JSP25-07 Cadillac of Novi

PLAN REVIEW CENTER REPORT

Revised Preliminary Site Plan / Special Development Option Amended Concept Plan

Review Date: July 16, 2025
Review Type: Preliminary Site Plan
Project Name: JSP25-07 Cadillac of Novi
Plan Date: June 23, 2025
Prepared by: Dan Commer, Planner
Contact: **E-mail:** dcommer@cityofnovi.org **Phone:** 248.735.5607

SHEET
Dimensional Site Plan

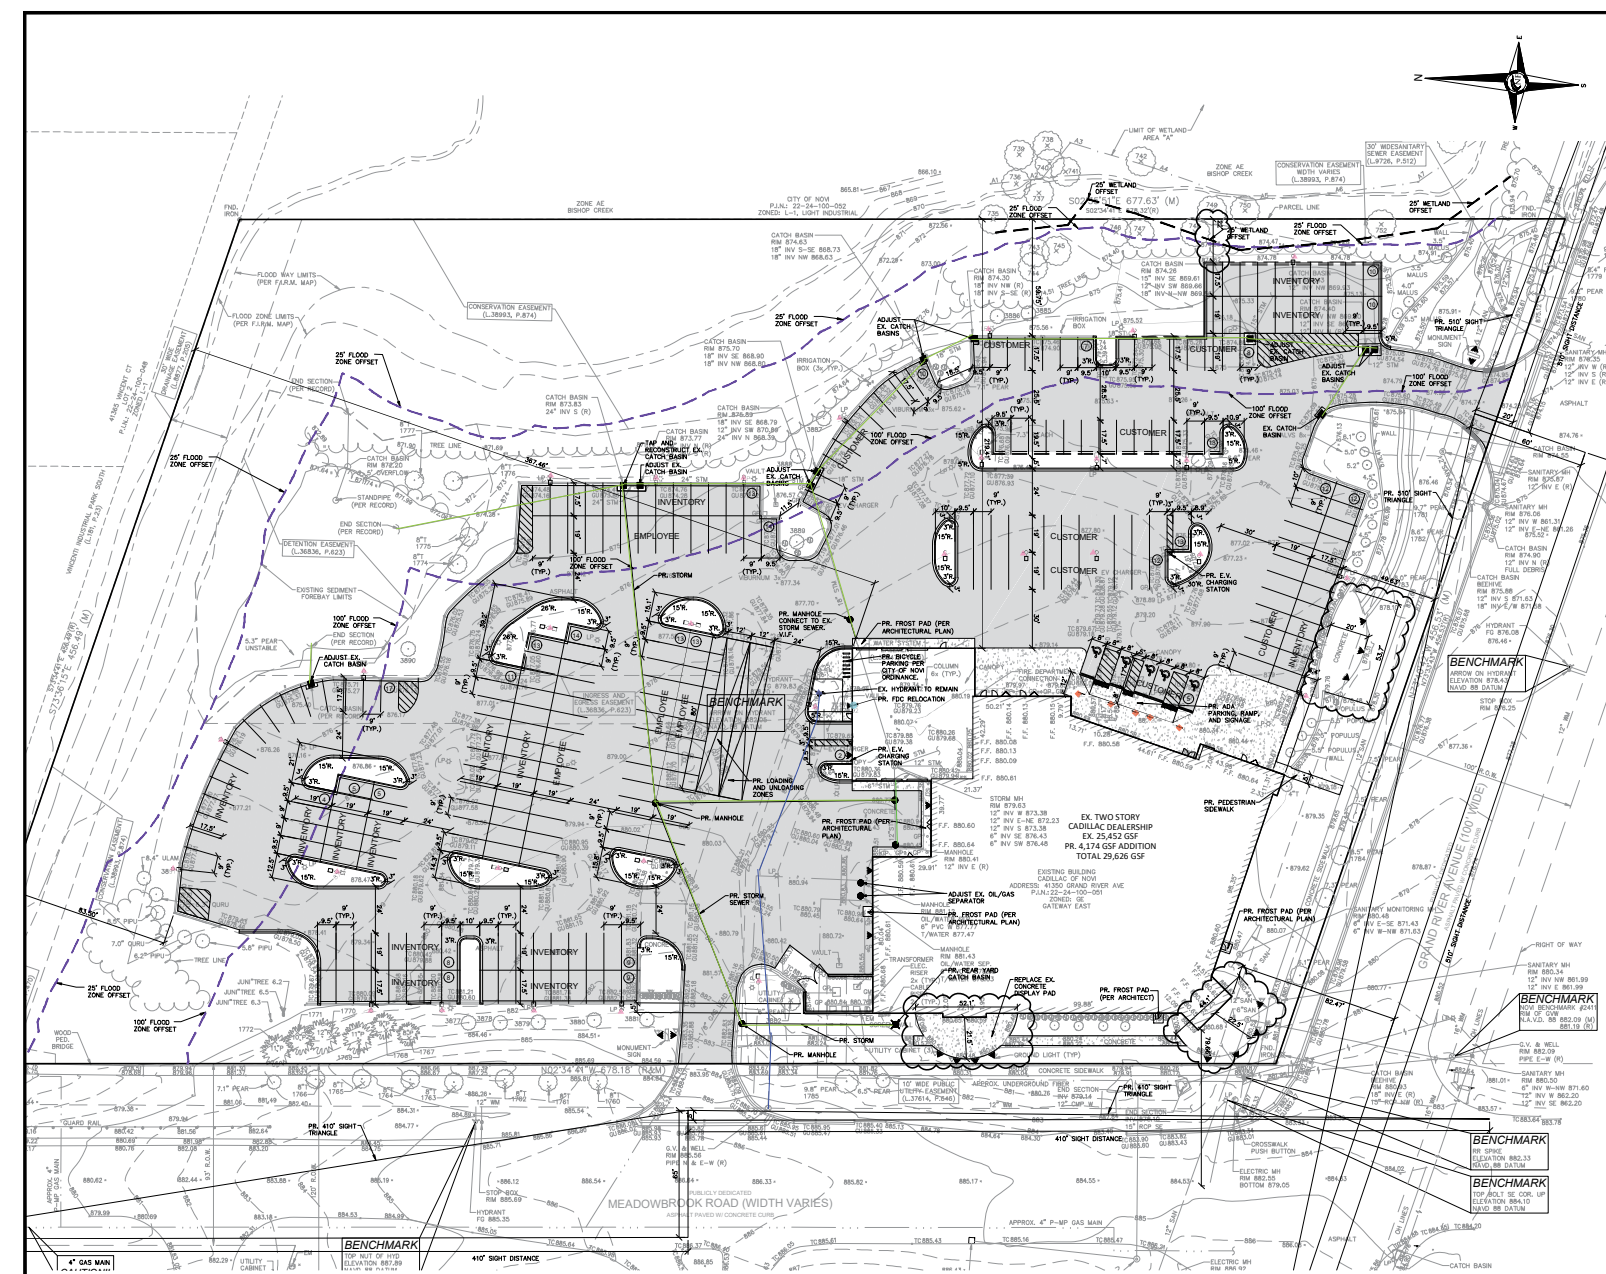
4. Indicate where the eight 'No Parking Fire Lane' signs are proposed. Show no parking signs on paving sheet C3 with other traffic control signs.
5. Provide a note that compacted sand backfill (MDOT sand Class II) shall be provided for all utilities within the influence of paved areas; illustrate and label on the profiles.

BICYCLE PARKING DIMENSION PLAN
SCALE: 1" = 60'

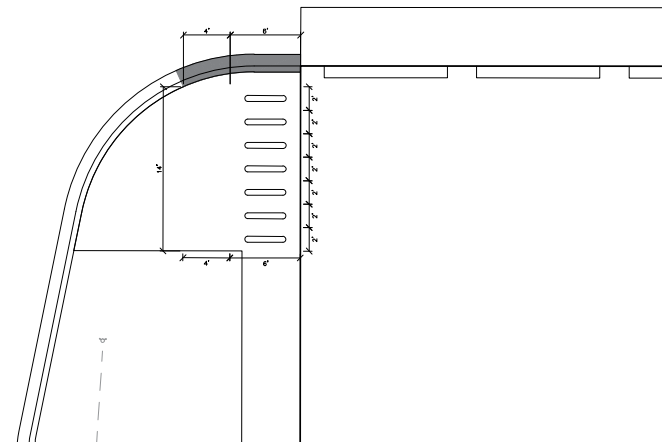
9. Bicycle Parking General Requirements (Sec. 5.6): The Preliminary Site Plan showed that all 7 bicycle parking spaces were provided in one location and the layout was not dimensioned. *A dimensioned bicycle parking layout has been provided on sheet C10 as requested with the revised submittal; however the dimensions are still citing the old standards, and all spaces are still proposed in one*

location. Please refer to Planning Review Chart for additional information, and see [Text Amendment 18.301](#) update to bicycle parking layout standards before Final Site Plan consideration.
